Field campaign

Topic	Underfloor paint drain hole check (SC22/14)
Market area	Russische Föderation (5RU),Australia E04 Bentley rest Asia and Australia (6E04),China 796 VW Import Comp. Ltd (Vico), Beijing (6796),Germany E02 Bentley rest Europe (6E02),Japan E03 Bentley Japan (6E03),Korea, (South) E08 Bentley South Korea (6E08),United Arab Emirates E06 Bentley Middle East and Africa (6E06),United Kingdom E01 Bentley UK (6E01),United States E05 Bentley USA and rest America (6E05)
Brand	Bentley
Transaction No.	2066738/1
Campaign number	EC40
Note	
Type	
US code

Bentayga

Figure 6

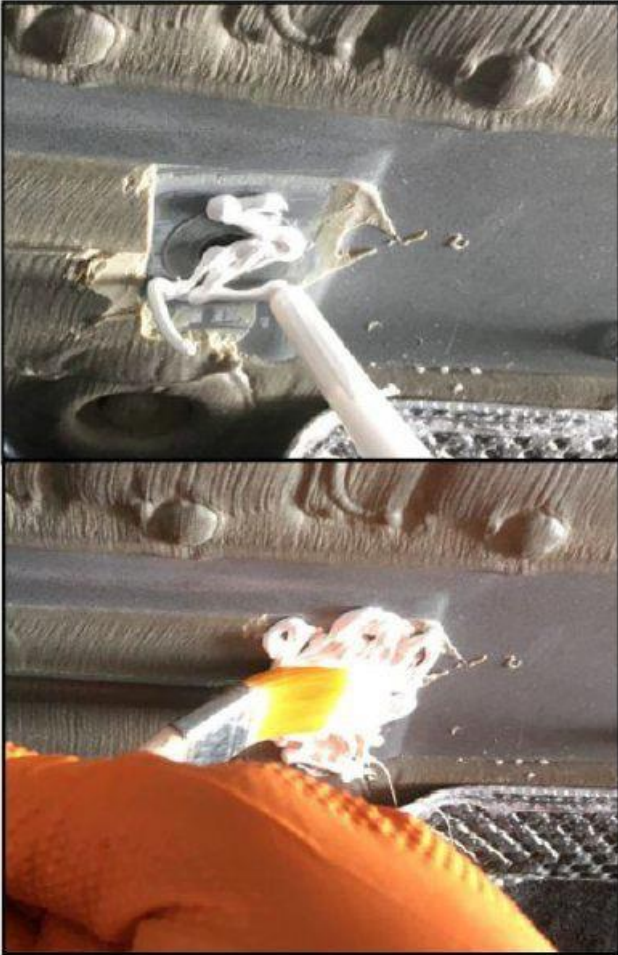
- Referring to back to Figure 1 - Using a suitable cleaning agent - Clean the area around the paint drain hole
- Referring to Figure 6 - Fit the Alubuthyl patch NOTE: The patch shown is not Alubuthyl however the instructions are the same and should be followed as instructed

- Using a suitable brush - Apply a smooth finish to the sealant/underseal
- 6) Referring to Rep.Gr 66 - Refit the left hand side undersheet
7) Place a blue paint completion mark in the location shown (Figure 7)

Figure 7

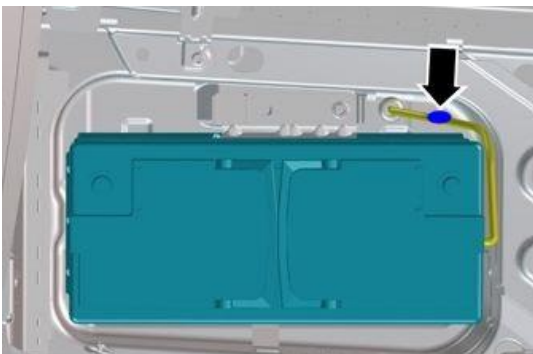
Blue paint completion mark on the 12 volt battery vent hose (Figure 7)
